UNITED STATES PATENT AND TRADEMARK OFFICE

Office Action Summary	Application No. 10/599,610	Applicant(s) WESTHOVENS ET AL.	
	Examiner KAUSHIKKUMAR DESAI	Art Unit 3788

DETAILED ACTION

2. Claims 1-6, 8-14, 17, 20, 24, 28-32, 35, 37 and 38 are rejected under 35 U.S.C. 103[a] as being unpatentable over US 2003/0164318 to Lacasse et al. in view of US 6691885 to Brown.

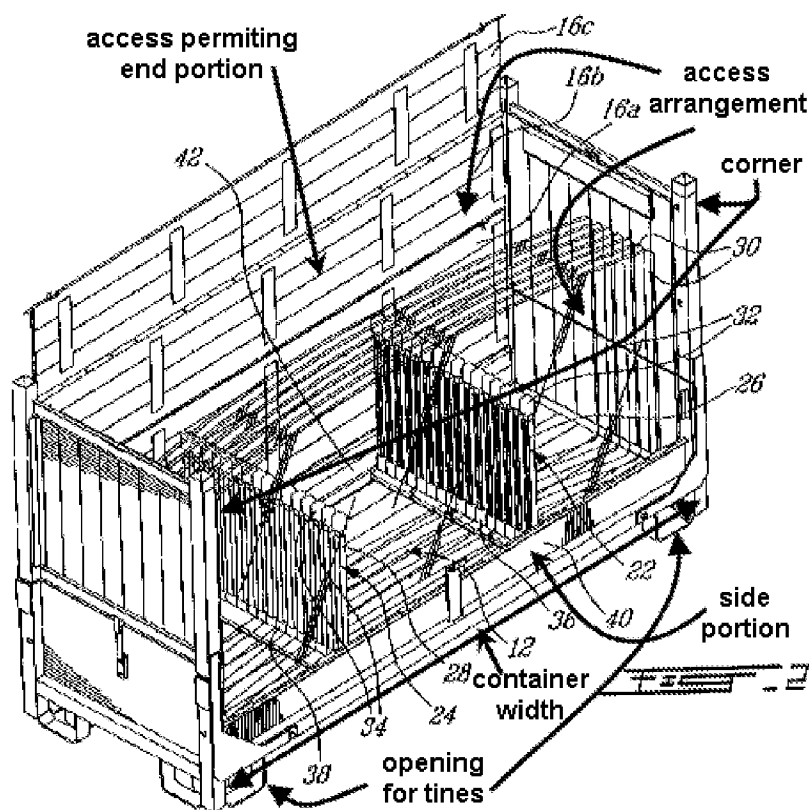
1, 12 and 35: Lacasse discloses a container [figs 1-3] for transportation and storage of items comprising an enclosure [see annotated fig 2 below] having an access arrangement providing access by means of an uppermost portion [open top, see annotated fig 2 below] and an access permitting end portions [fig 2] bounded by a corner [top] of the container; as functionally claimed a securing arrangement comprising an upright restraints [22/24] are configured to be advanced [fig 2] and retracted [fig 3] across the width of the container for supporting long, irregularly shaped bulk products in an upright orientation [e.g. fig 2]. Lacasse further comprises movable side panels [16 and 14] proximate access permitting end portions. It has been held that when element is functionally claimed, e.g., configured to, is considered a functional language and is treated as intended use or result to be achieved and only requires the ability to so perform. It does not constitute a limitation in any patentable sense. MPEP 2111.04 (A).

10: Lacasse/Brown discloses that the frame openings on the lower portion of the container for receiving tines of a lifting apparatus [see annotated fig 2 above].
